Detailed Site Plan Discovery District

DSP-22024

SUBJECT: Detailed Site Plan DSP-22024
 Discovery District

The Urban Design Section has reviewed the detailed site plan for the subject property and recommends APPROVAL, with conditions, as described in the Recommendation section of this technical staff report.

Figure 3: East Elevation Showing Loading Space Entrance

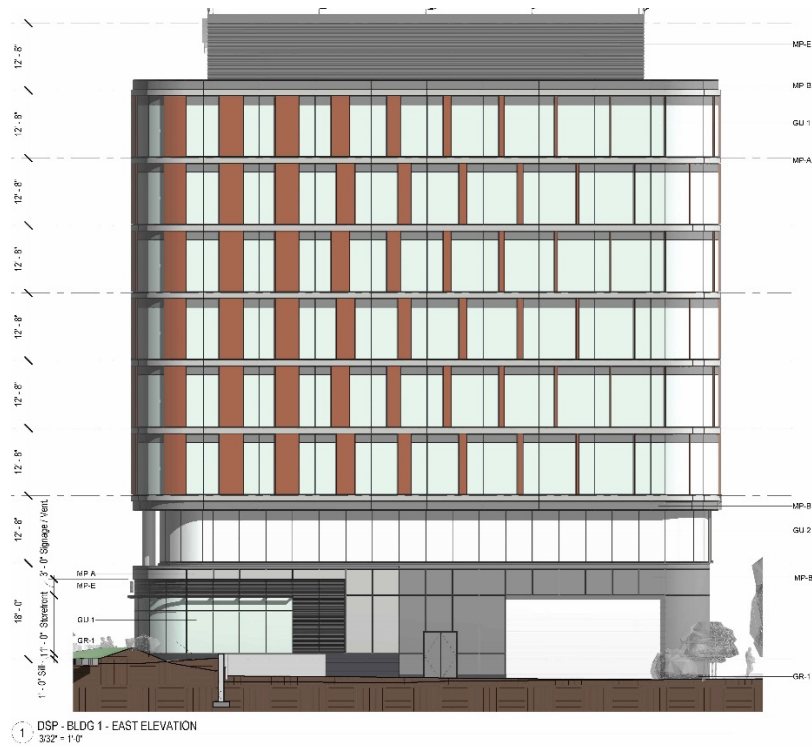
The loading area for the proposed development will be located internal to Building 1, to be accessed from Campus Drive. The loading area access will be minimally screened by 13 evergreen trees.

The applicant states in their SOJ that it is impractical to locate the loading area 30 feet away from the public sidewalk along Campus Drive. The loading area is currently proposed to be located in Building 1, with access from Campus Drive. The phasing plan on Sheet 1 of the DSP shows that Diamondback Drive, north of Testudo Way, will be removed prior to or concurrently with the completion of the intersection of Testudo Way and Campus Drive. A right-in/right-out turning lane at

Due to the curved geometry of the site and the building's proximity to Campus Drive at the rear, it is not feasible to locate the loading garage access 30 feet from the sidewalk. The landscape design incorporates a hedge to minimize the impact of the view to the garage as much as possible. Delaying parking lot screening in this phase should not substantially impair implementation of the plan. As a result of these reasons, staff recommend **approval** of these amendments.

Figure 5: Proposed Sign Types

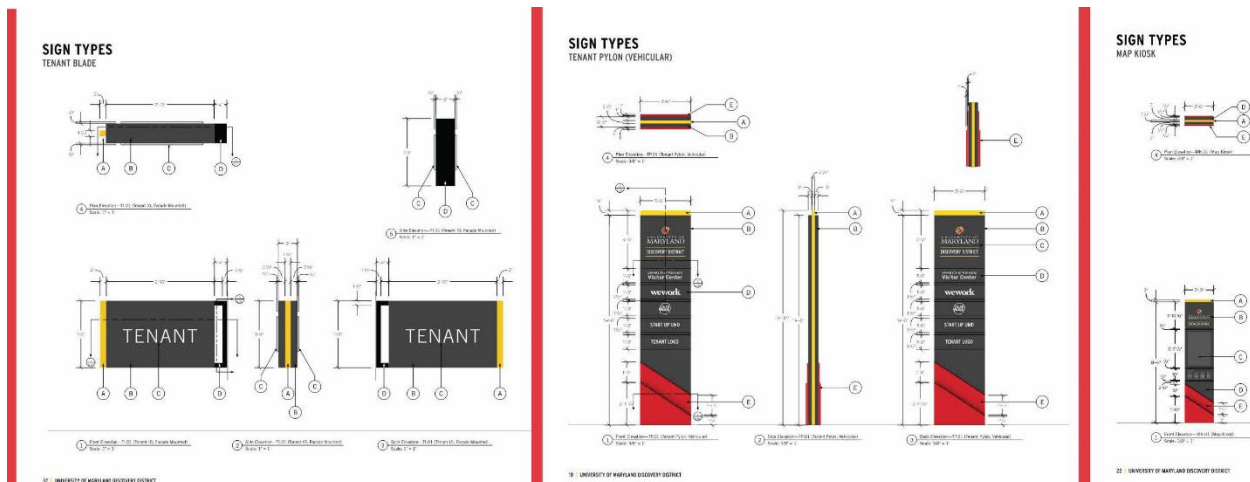
The applicant proposes a variety of signage types including tenant blade signs, tenant pylon signs, facade signs, window signage, map kiosks, and gateway pylon signs. All signage except for the wayfinding signs will be building-mounted. Building numbers are proposed to be visible from the internal plaza. The large “Discovery Point” identity signage at the top of Building 1 is currently designed with a maximum letter height of 5 feet, to provide for greater legibility given that the sign will be 126 feet above grade. A condition has been included herein, to provide signage detail for the “Discovery Point” sign, which is shown on the Building 1 elevation, but is not shown on the building signage sheet.

The submitted sign details for the project include the square footage for each sign type, but not all the details required to fully evaluate conformance with the sign requirements of the D-D-O Zone (page 254 of the sector plan). The maximum gross area of signs on a given façade shall not exceed 10 percent of the façade area of the commercial portion of the building, though architectural signs or signage painted on a building façade or mounted on the roof may exceed this limit, in certain cases. A condition has been included herein, requiring the applicant to demonstrate conformance with the applicable sign requirements.

- j. **Architectural Elements/Signage (page 254):** The sector plan states that a single external sign band may be applied to the façade of each building, provided that such signs shall not exceed three feet in height. The proposed development shows a surface mounted identity sign at the top of Building 1 with a maximum height of five feet. The increase in height for the signage is to provide greater legibility given the sign will be mounted 126 feet above grade. Staff find that given the placement of the sign at the stated elevation, the proposed letter height is appropriate and should not substantially impair implementation of the plan. As a result of these reasons, staff recommend **approval** of this amendment.
